Bull Run Terrace

Planning Commission 8/24/2020

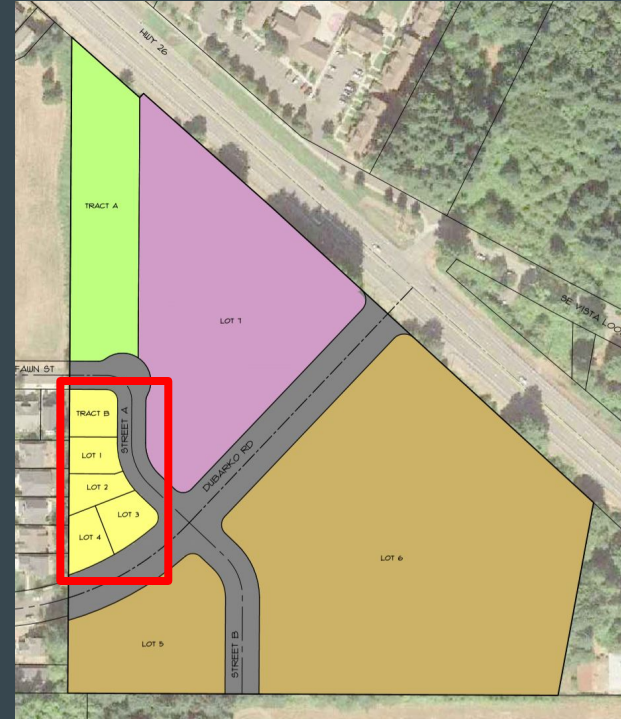
- Lots 1-4
- Meets density requirements
- Staff questions to building potential on lots 3 and 4; these lots will have reduced buildable area as a result of required setbacks and easements. Staff has recommended that the applicant submit a building footprint plan prior to City Council hearing.

High Density Residential (R-3)

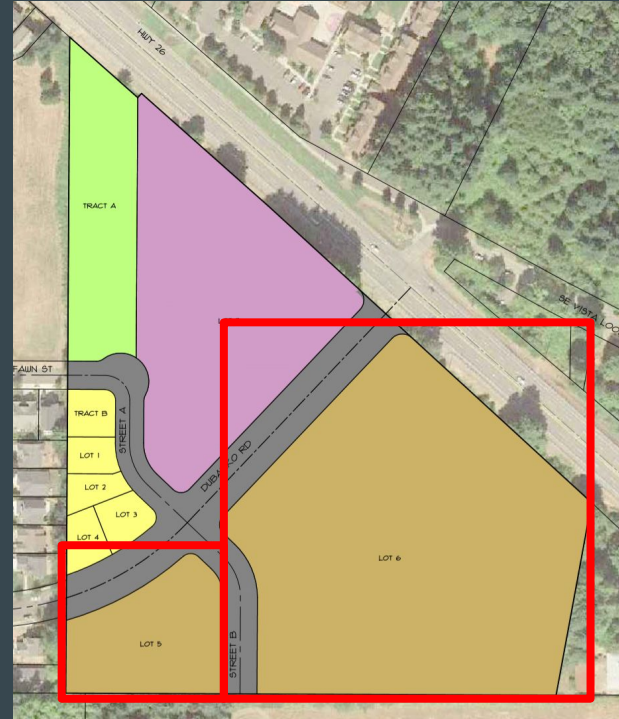
- Lots 5-6
- Density requirements allow for a maximum of 158 units
- The future design review application will include a review of development standards, minimum requirements, and additional requirements.

Village Commercial (C-3)

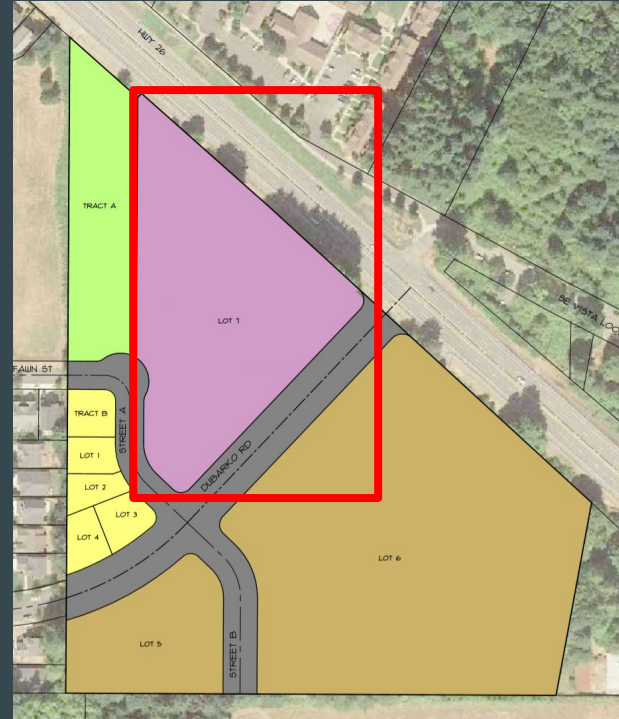
- Lot 7
- Allows for mix of commercial and residential uses
- The future design review application will include a review of development standards, minimum requirements, and additional requirements.

Park Dedication

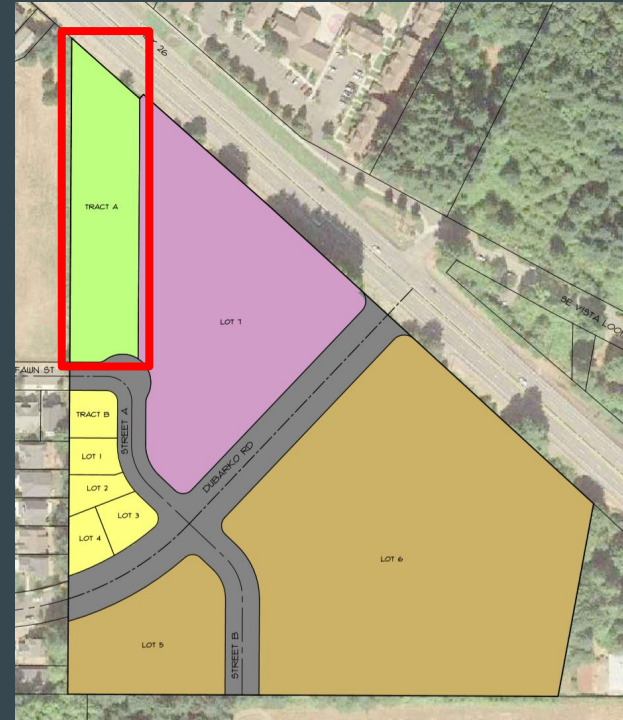
- Requires 1.41 acres, and applicant is proposing 1.426 acres
- Staff recommends that the design review approval for Lot 7 shall include activated frontages facing the parkland
- Staff recommends that the applicant install a walkway along the east side of the park or west side of Lot 7 that connects Fawn St to the sidewalk along Highway 26.

Park Dedication (cont.)

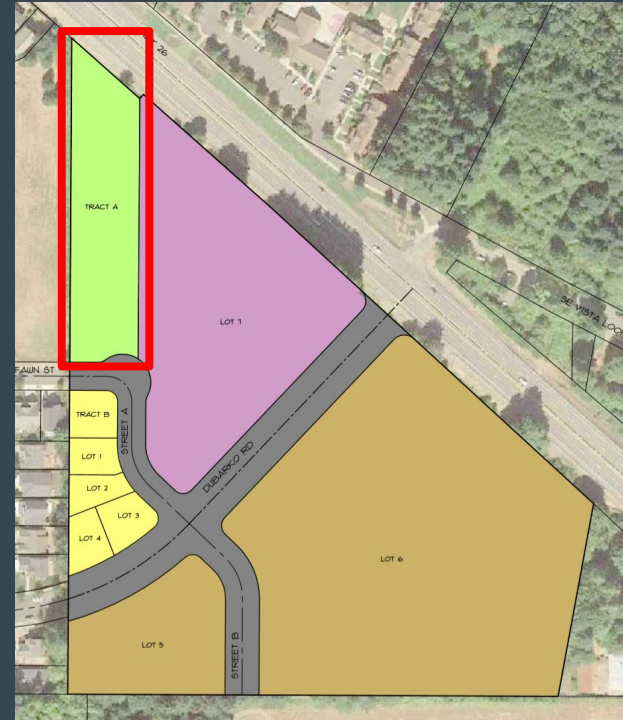
- Staff recommends that the design review approval for Lot 7 incorporate a landscape buffer that provides visibility between Lot 7 and the parkland but provides a visually attractive separation.
